Notice of Allowability

10/628,907

SCHAUPP, JOHN F.

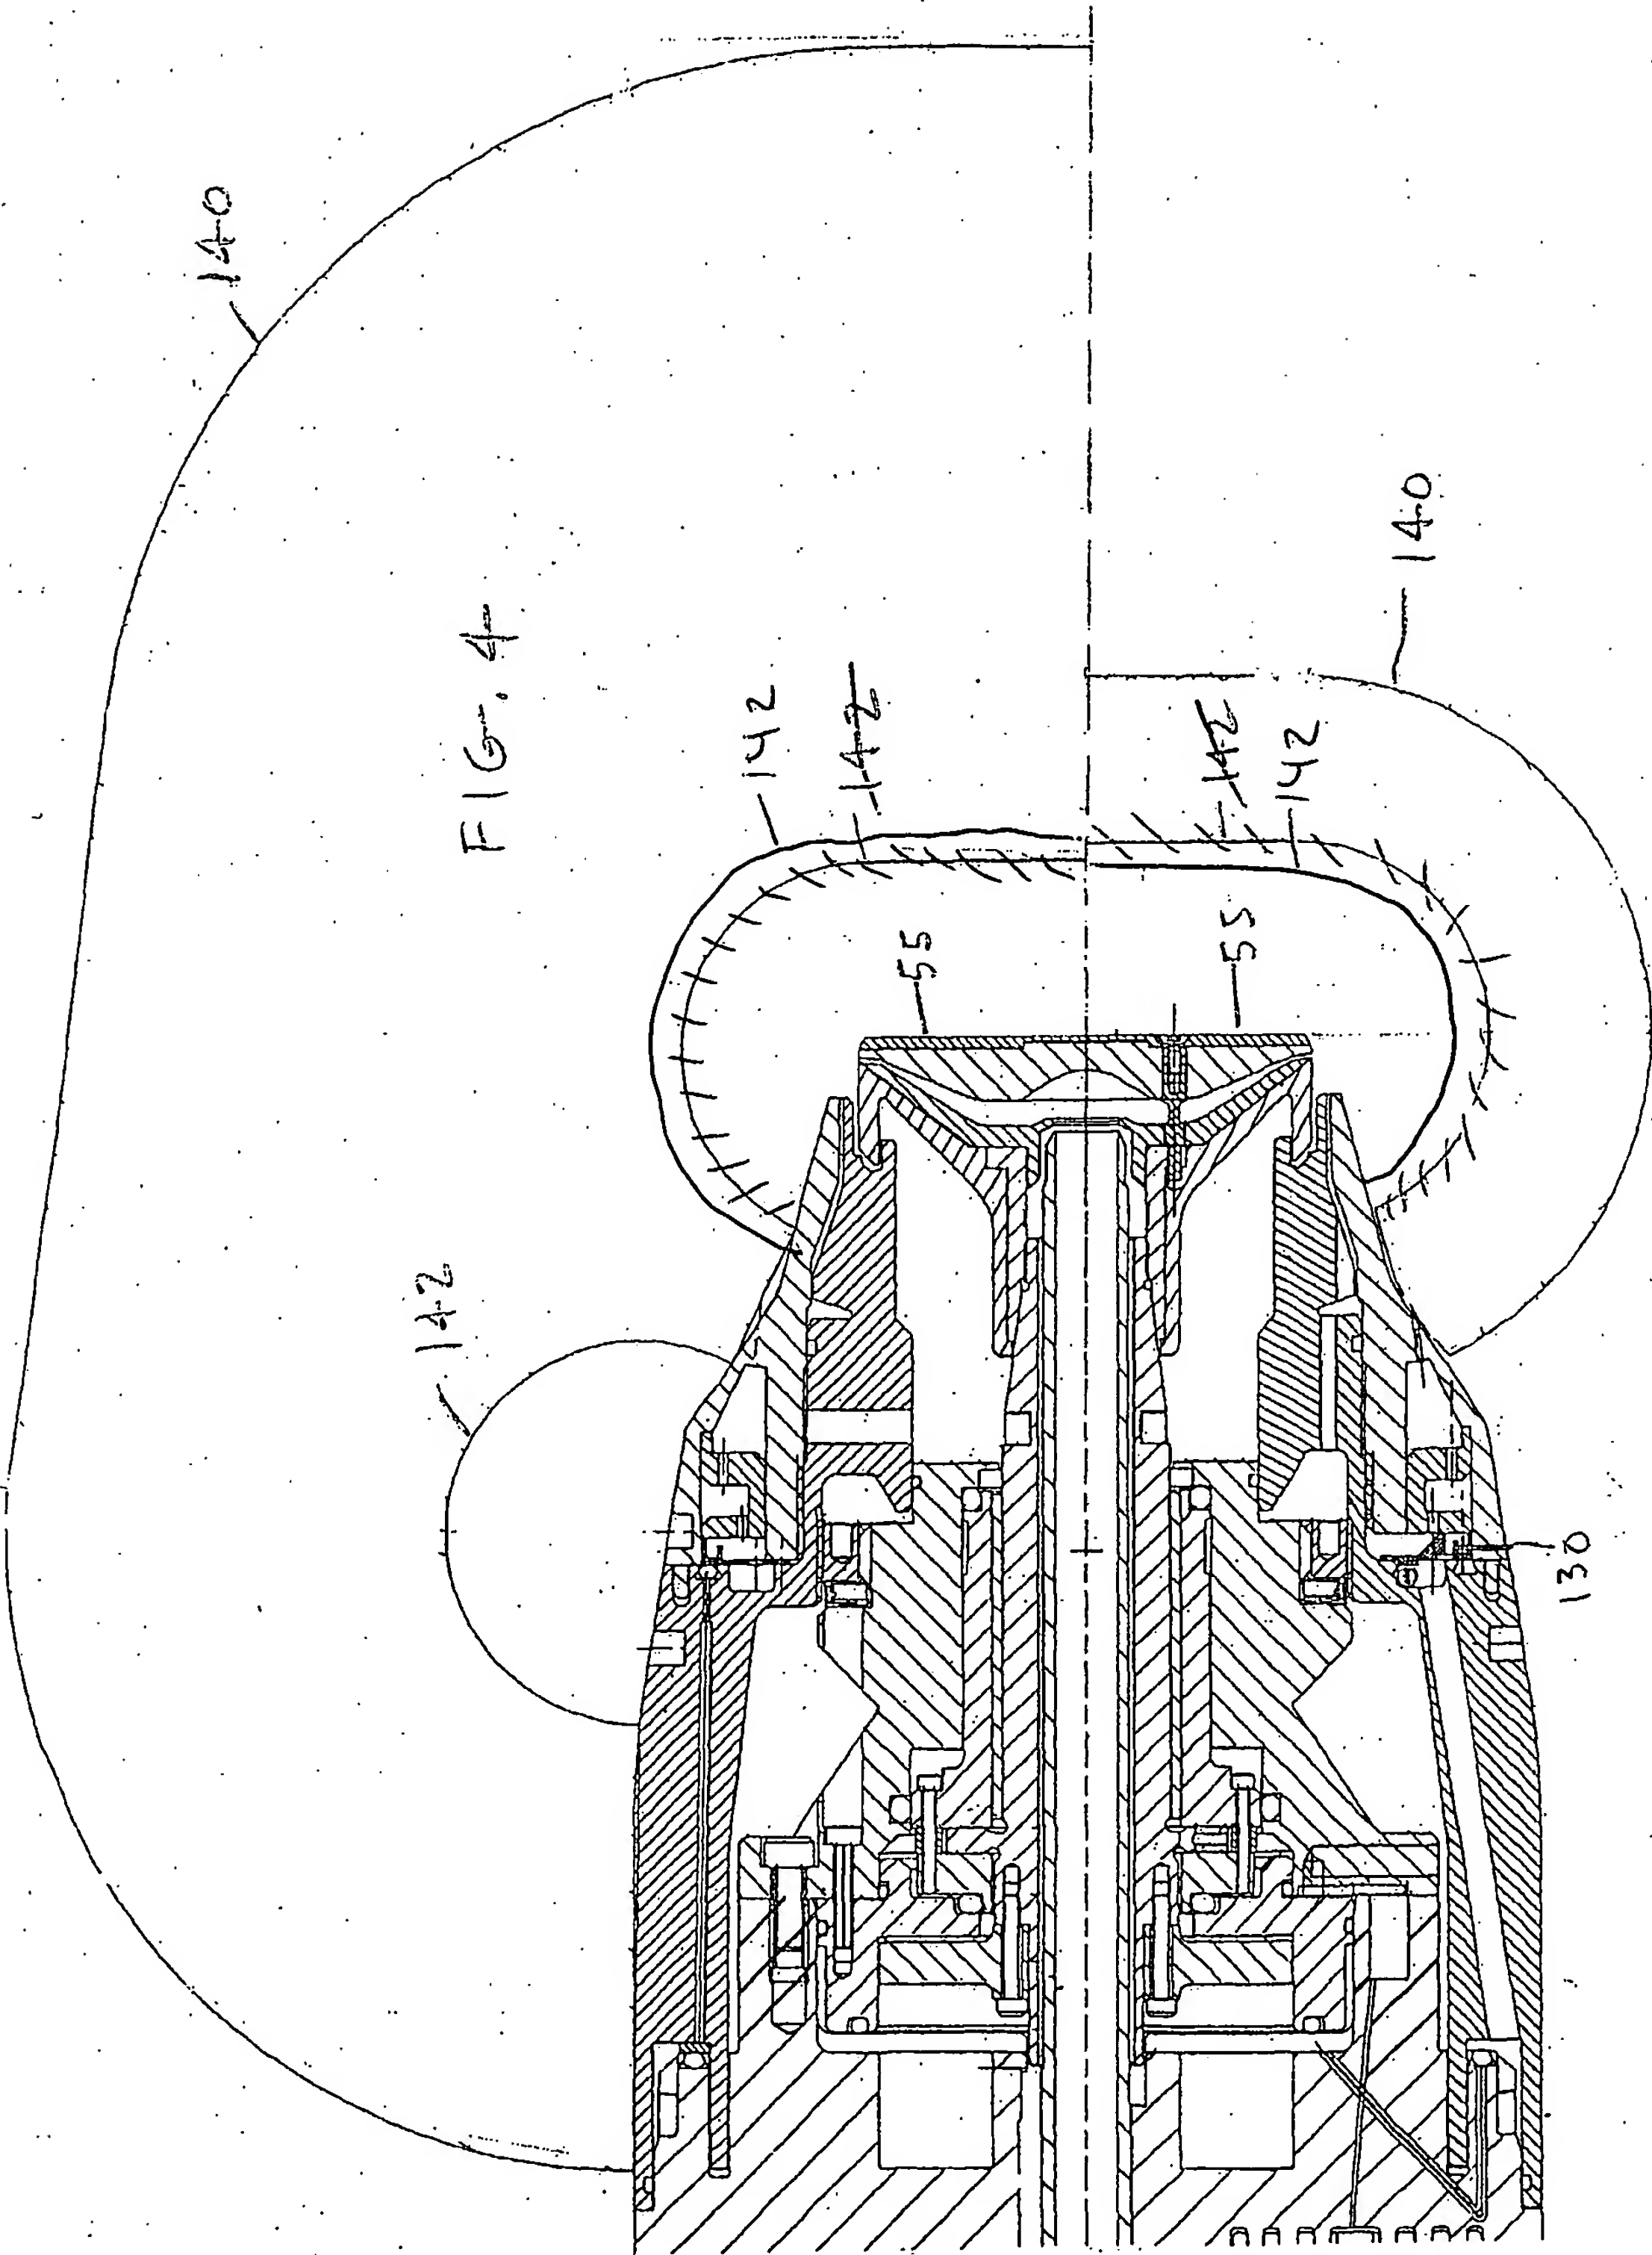
3. The following changes to the drawings are required to be made by applicant: In Figure 4, the equipotential line 142 in the upper half does not extend further than the equipotential line 142 in the lower half. Per the specification, page 8, lines 10-14, it is disclosed that the equipotential lines 140 and 142(of the upper half) extend much farther from the charging electrode 55 both forwardly and rearwardly, than the equipotential lines 140 and 142 (of the lower half). It appears that the two lines may have been inadvertently inverted when drawn in the Figure. The drawing should be corrected to show the equipotential line 142 in the upper half extending further than the equipotential line 142 in the lower half. See attached drawing sheet showing correction. In order to avoid abandonment of the application, applicant must make these drawing changes.
